# Analysis of Salton Sea Restoration Plans

*submitted by*  
**PARSONS**

Parsons was retained by the Salton Sea Authority to perform an independent technical review and critique the Phase 1 alternatives described in the Draft Salton Sea Restoration Project Environmental Impact Statement/Environmental Impact Report (EIS/EIR). Fatal flaws, as well as possible refinements, in the alternatives were to be identified. Possible Phase 2 actions/concepts were to be briefly evaluated, primarily from a cost-effectiveness point of view. In addition, other possible salinity and elevation control actions were to be identified and suggestions for further analysis were to be made.

Figure 3-2 – Dike Seismic Vulnerability versus Water Depth

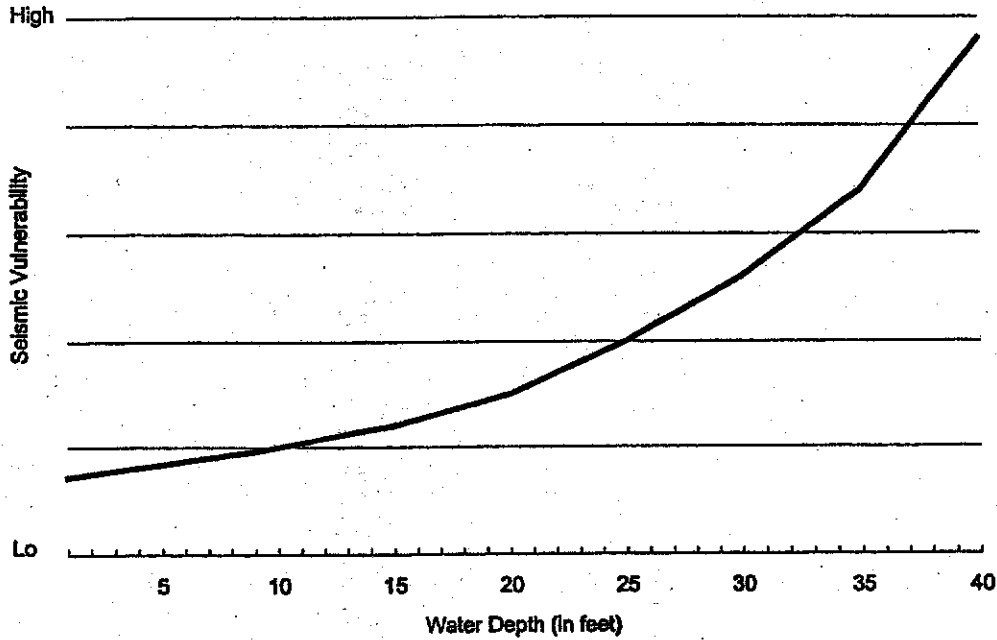
Consideration should also be given to minimizing the heights of the dikes to minimize the cost of the ponds. The seismic vulnerability would also be reduced with the lower height dikes because the internal shear stresses and magnitude of possible seismic slumping will be less. Figure 3-2 shows the conceptual relationship between seismic vulnerability and dike height.

The quantity of material needed to construct a 17-foot-high dike would be 70 to 75 percent less than for a 35-foot-high dike (assuming both have crest widths of 30 feet and side slopes at  $3\frac{1}{2}:1$ ). Since, the cost for constructing the dikes is driven primarily by the amount of borrow material placed, the linear cost for a 35-foot-high dike would be about three times the linear cost for a 17-foot-high dike. Figure 3-3 presents a hypothetical example for optimizing the height of the south pond dikes. This figure presents the estimated dike volume for enclosing equal areas of the Sea for use as an evaporation pond at various average water depths along the dike alignments. This example indicates that an optimum dike height might be about 20 feet (5 feet of foundation excavation plus 8 feet of water plus 7 feet of freeboard). However, it does not consider effects on stream inflows, near-shore habitats, etc. Dike construction cost needs to be balanced with such effects. Similar

optimization studies should be completed using actual dike configurations and seafloor bathymetry.

Figure 3-4 - Typical Slump Failure

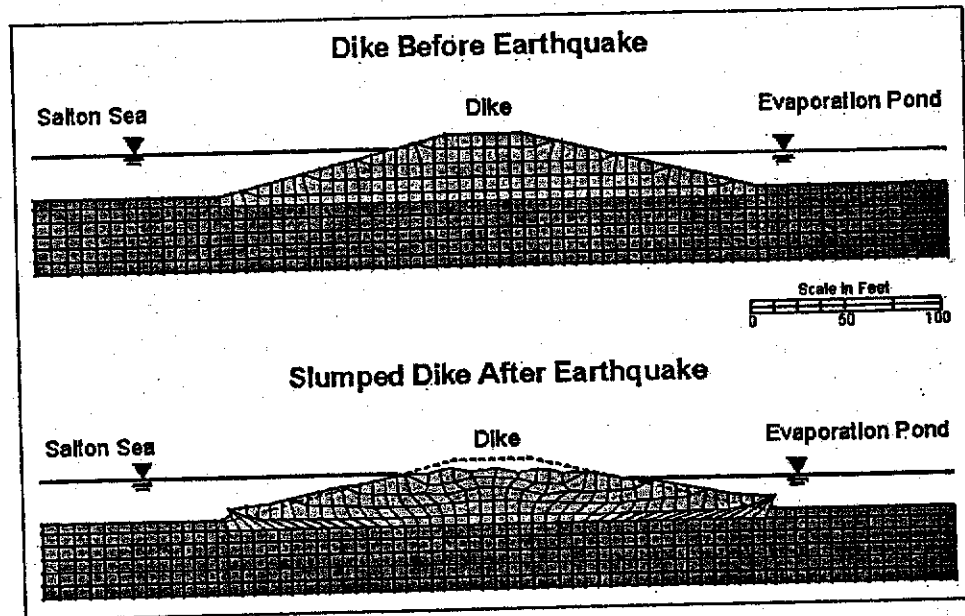
It is desirable to construct the dikes with 3½:1 side slopes so that if liquefaction were to occur (and there is a high potential for this to occur), the dikes would "slump" rather than have slope instabilities. Dikes with 3½:1 slopes should slump rather than have catastrophic slope failures if the dike soils liquefy. The dikes may slump 20 percent of their height (7 feet for 35-foot dike). Figure 3-4 shows a typical slump failure. However, little is known about the Sea bottom conditions along the dike alignments, and additional slumping/settlement could occur if the foundation soils were to liquefy.

We recommend that seismic response analyses be performed to evaluate the effects of liquefaction and ground shaking on the dikes. This will require investigation of the dike and foundation materials and their response to anticipated ground shaking. We recommend that explorations be performed to evaluate the probable foundation materials and characteristics of the proposed borrow materials for dike construction. Material properties can be developed for the response analyses by using samples and data obtained from the explorations. Computerized simulations of the response of the dikes using the developed material properties and anticipated earthquake ground motions can be used to evaluate the required dike geometry.

Figure 3-6 - Cellular Sheet Pile Cofferd Dam

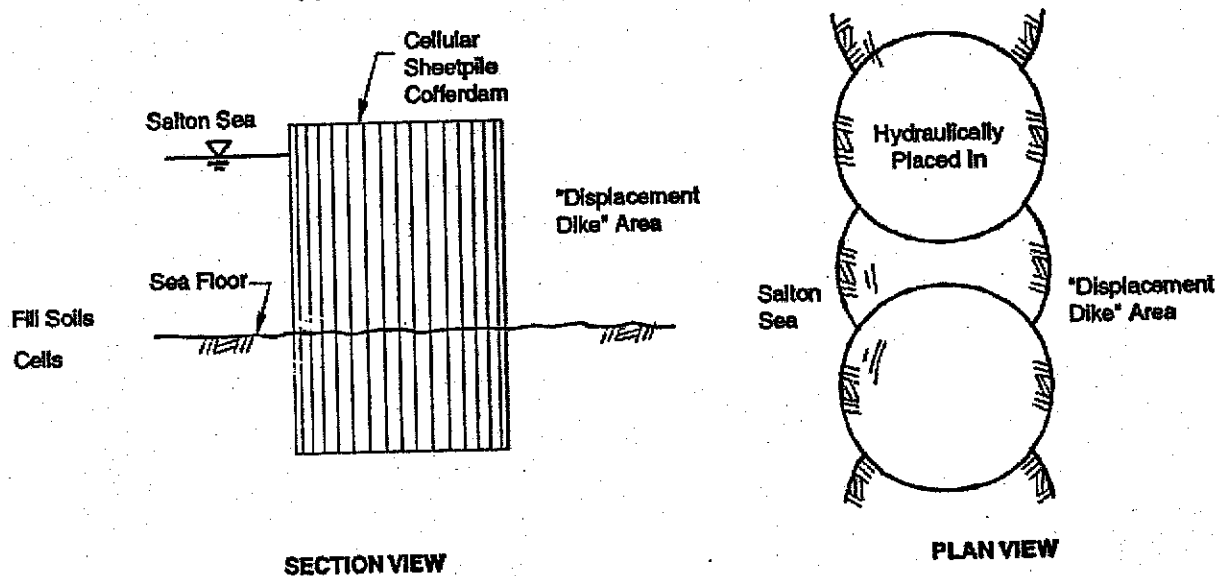
As an alternative to the displacement dikes, consideration should be given to reclaiming part of the Sea with dredged materials. This would eliminate concerns about the large differential head across the dikes and the consequences of a potential dike failure. The reclamation could be positioned along existing contours such that when the Sea level drops, the top of the reclamation fills would be exposed, reducing the Sea's surface area. This is shown schematically in Figure 3-5

(above the Sea floor) of 30 feet. A 17-mile barrier would cost approximately \$835 million.

Figure 4-5 - Net Present Value of Phase 1 Alternatives through Year 2030<sup>3</sup>

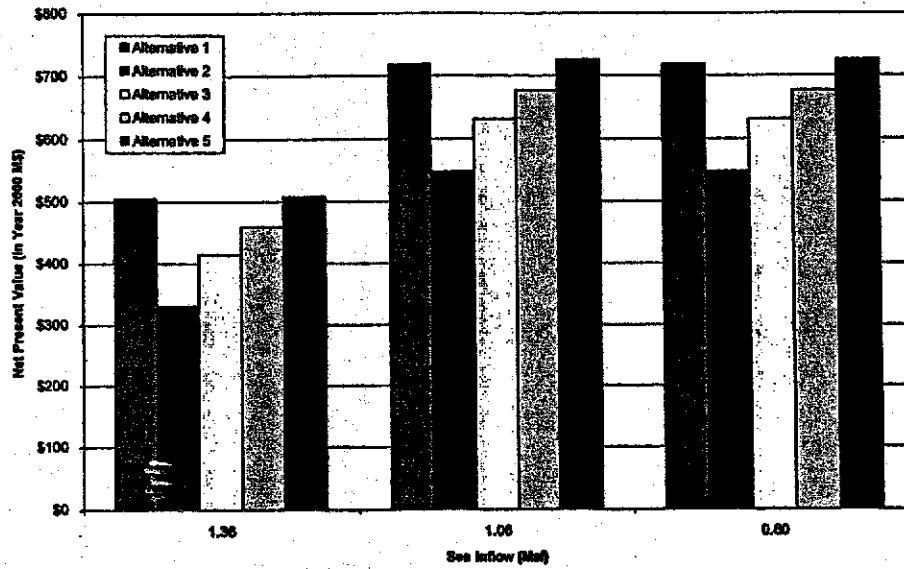
A net present value comparison of the alternatives was performed and is shown in Figure 4-5. The construction and annual costs used in the net present value comparison are shown in Table 4-6. These costs were adjusted from those generated by the Bureau of Reclamation to reflect additions and changes made to achieve a minimum 30-year life for each of the alternatives. All costs are based on appraisal level estimates.

An increase or decrease in the annual salt removal needed would increase or reduce the net present value significantly for the high-annual cost alternatives (those with an EES), but would not affect the net present value of the low annual cost alternatives as much. This also reinforces the need to refine the annual costs for the alternatives.
